**PASCAGOULA PUBLIC LIBRARY
REPAIRS AND RENOVATIONS
JACKSON COUNTY BOARD OF SUPERVISORS
PASCAGOULA, MISSISSIPPI**

00.910 ADDENDUM NO 1.

This Addendum forms a part of the Contract Documents and modifies the original Bidding Documents. The following clarifications, changes, additions, or deletions shall be made to the following documents as indicated and all other conditions shall remain the same.

1 FIRST FLOOR PLAN - NEW MECHANICAL
 M101R 3/32" = 1'-0"

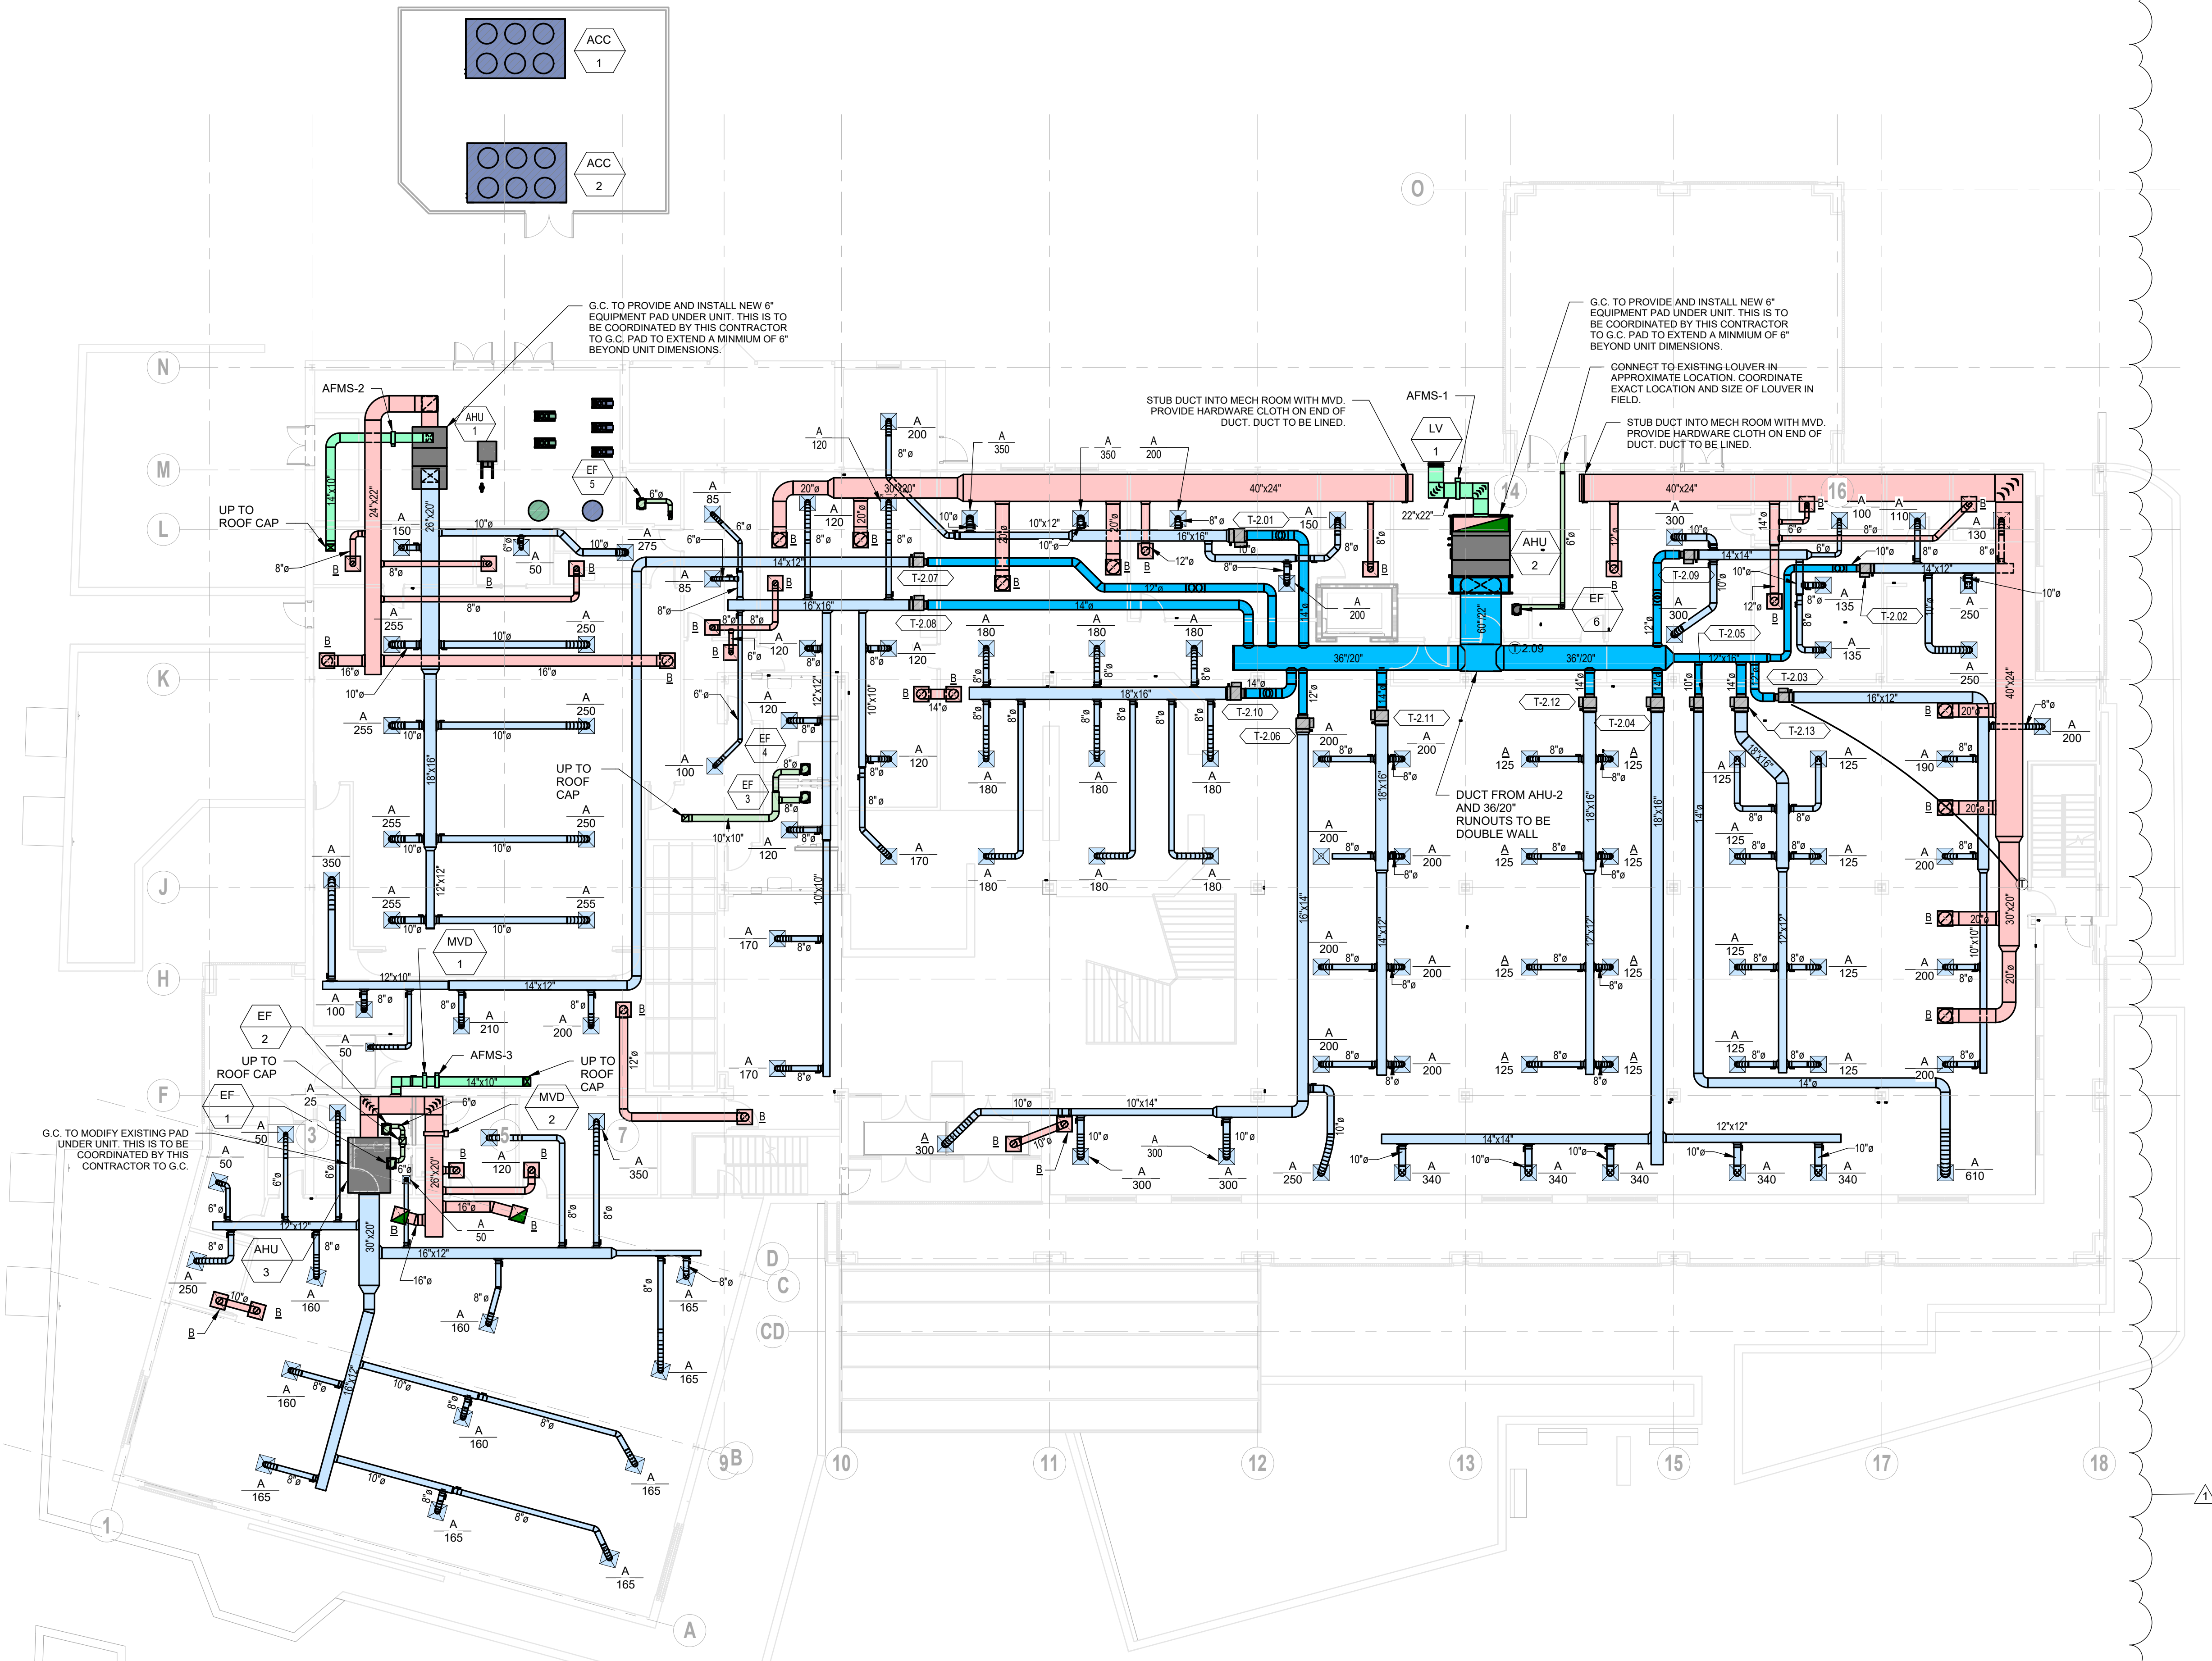
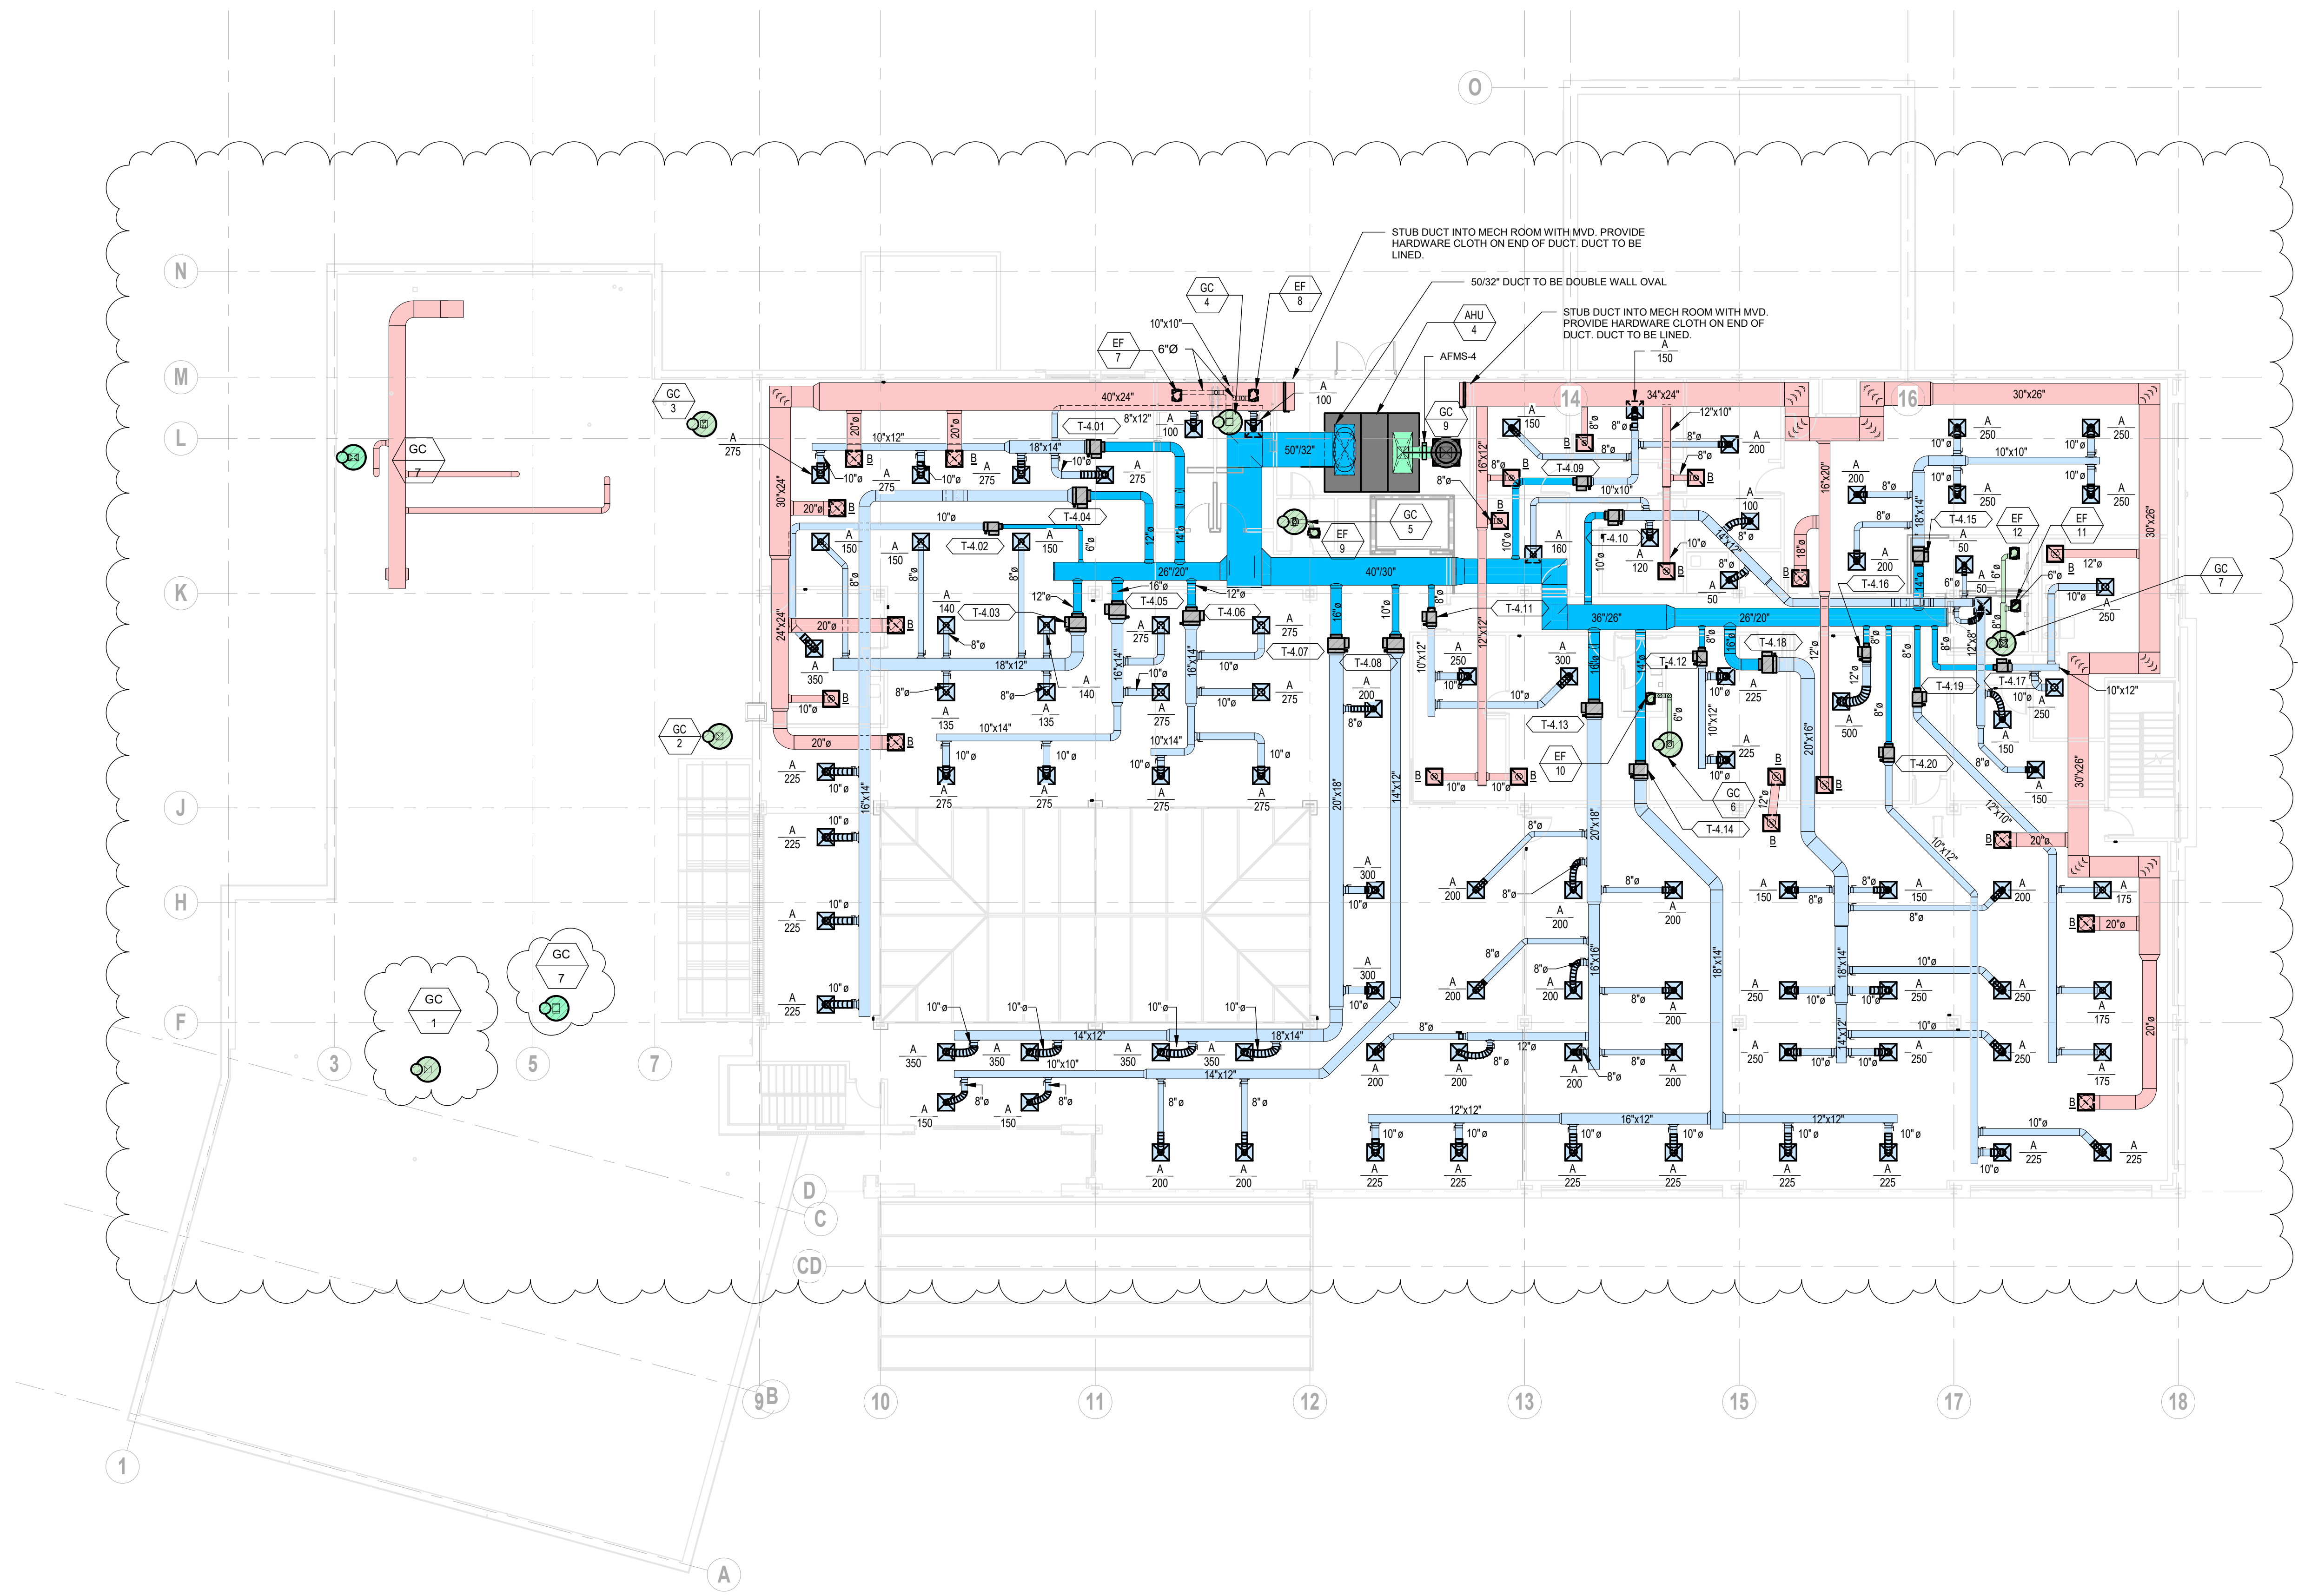
6. SHEET M001
 - A. Delete and Replace with M001R.
7. SHEET M101
 - A. Delete and Replace with M101R.
8. SHEET M102
 - A. Delete and Replace with M102R.
9. SHEET M103
